City of Oakley
ADDENDUM NO. 1 to contract documents for
OAKLEY COMMUNITY DOG PARK – PHASE 1 PARKING LOT
PROJECT, CIP # 197

BID OPENING DATE: June 29, 2017 2:00 PM

Notice is hereby given that the following clarifications and revisions are made to the above referenced contract documents:

SHEET
C6.0
 JOB NO.
 223004

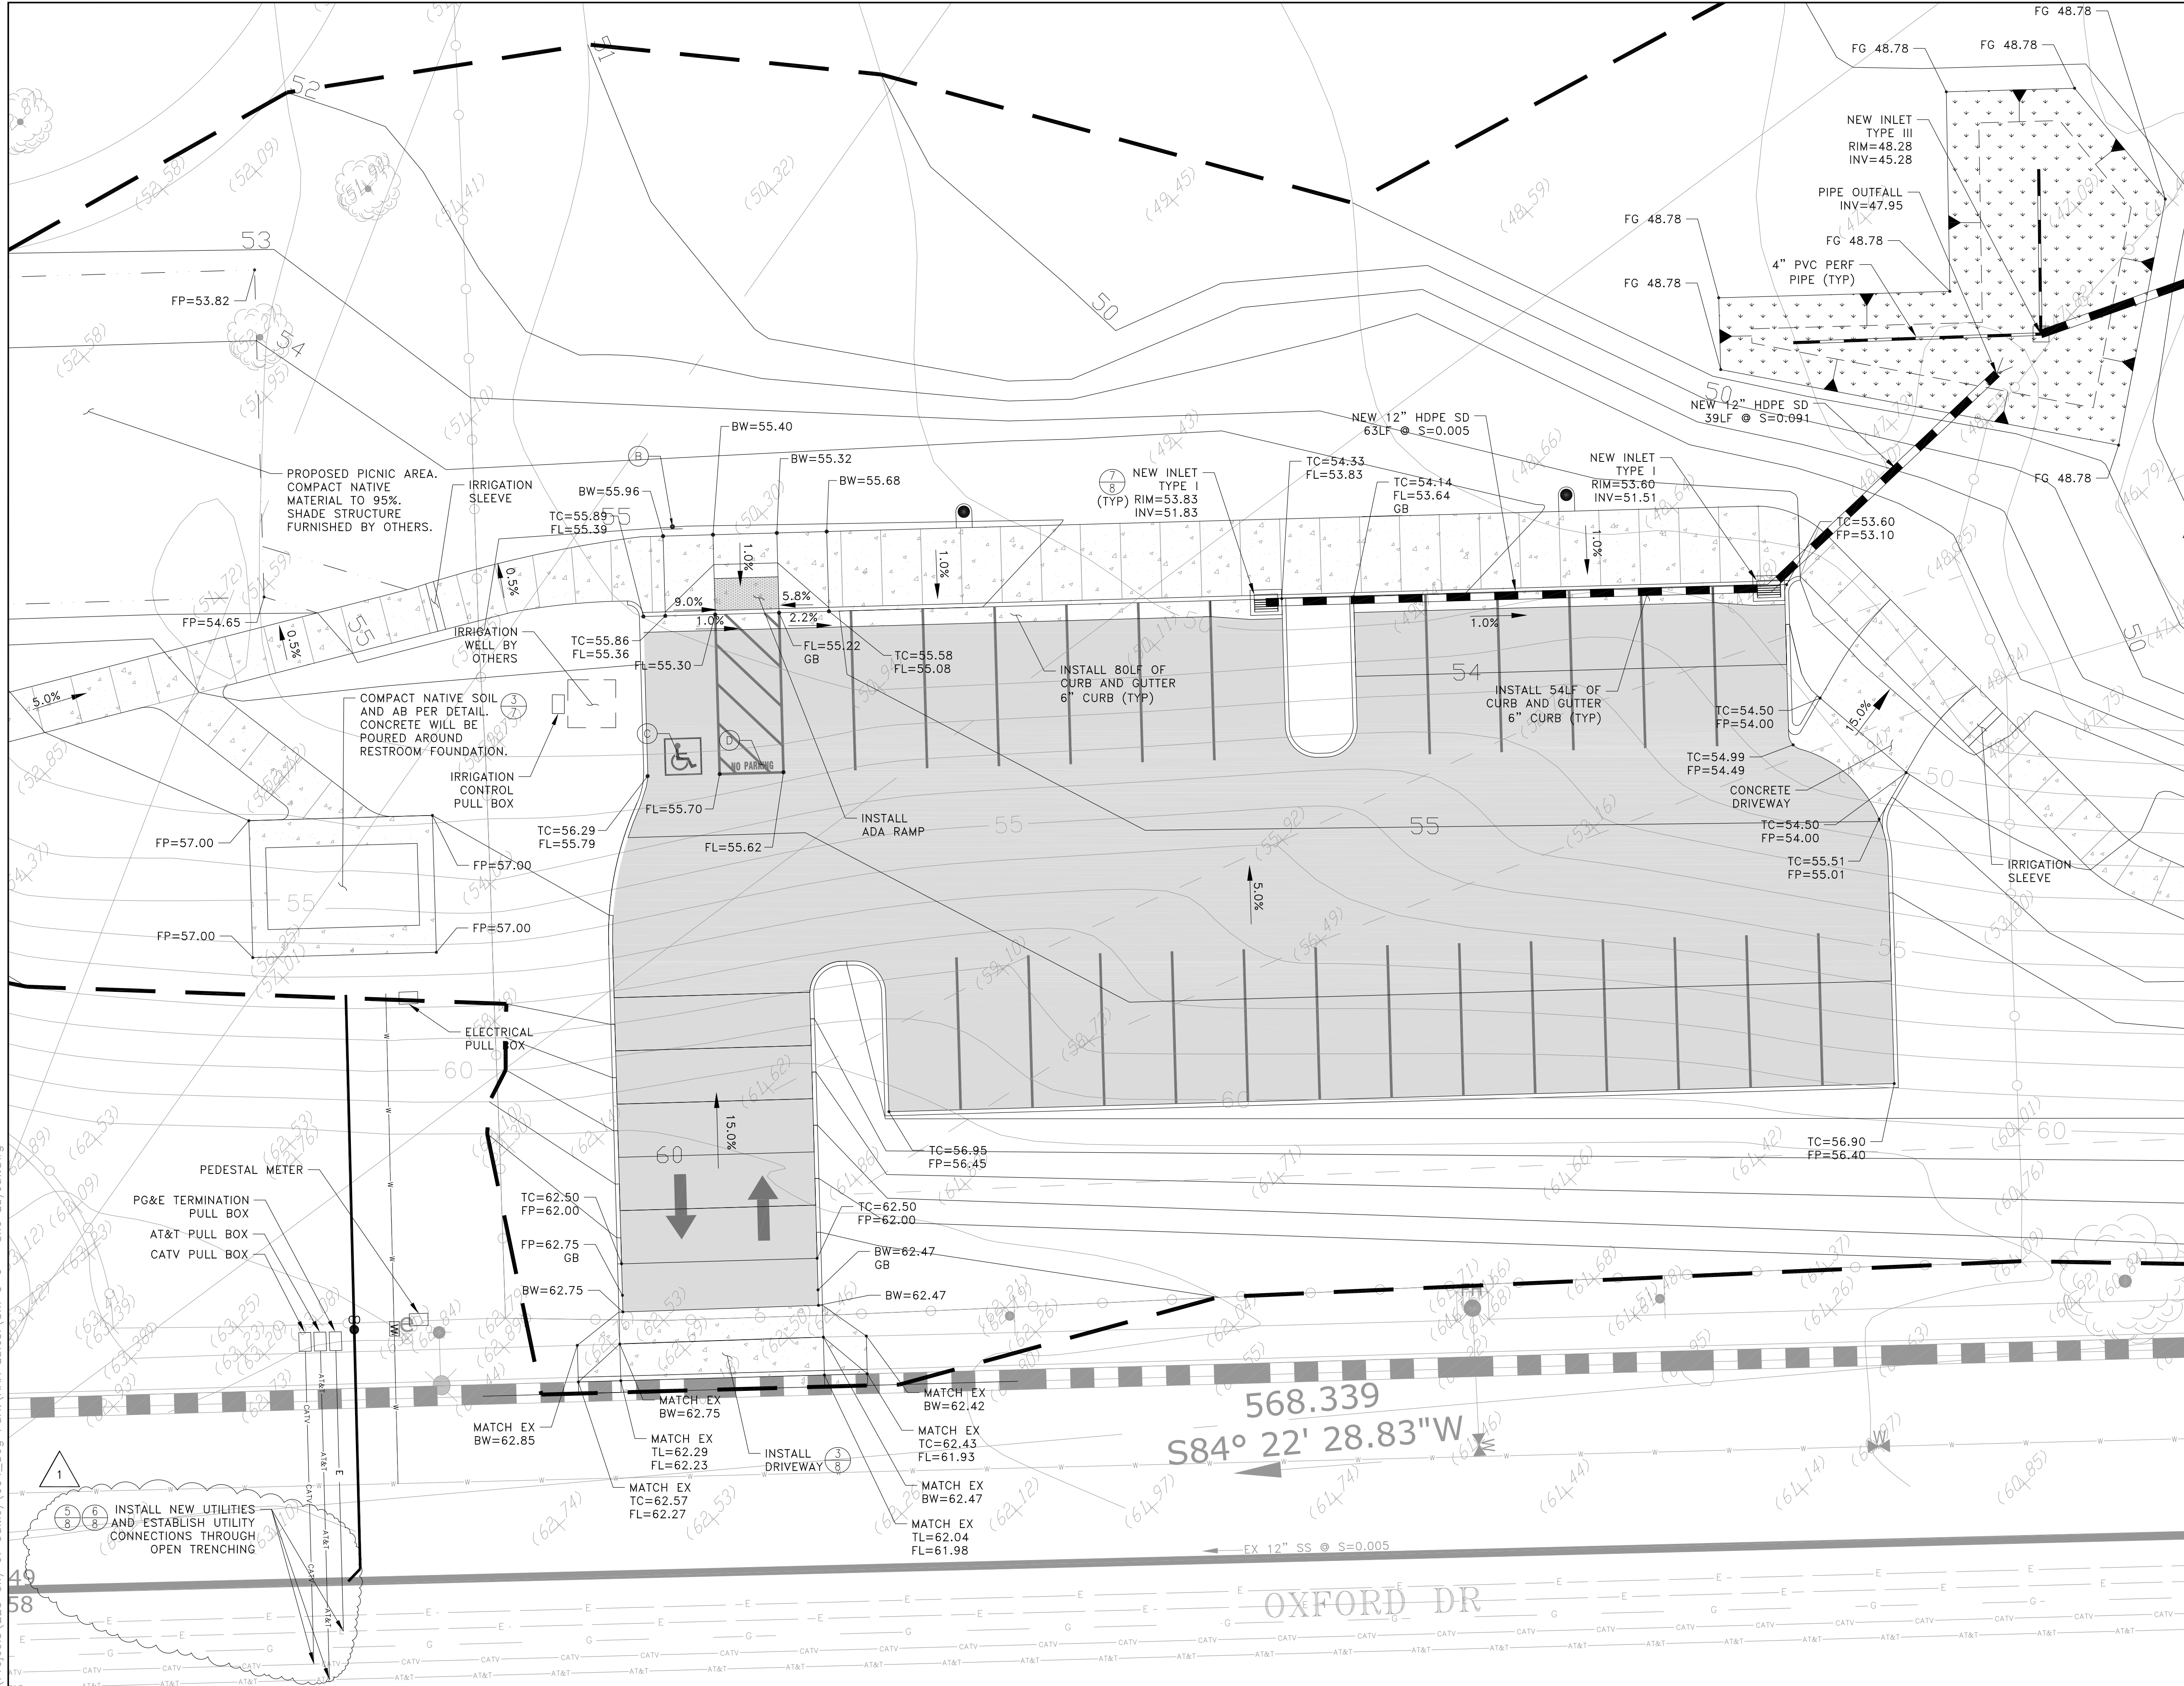
Sheet C6.0

- o Trench work for pull box and utility connections

DATE	DESCRIPTION OF REVISIONS	APPD
6/22/17	ADDENDUM 1: TRENCH CALLOUT
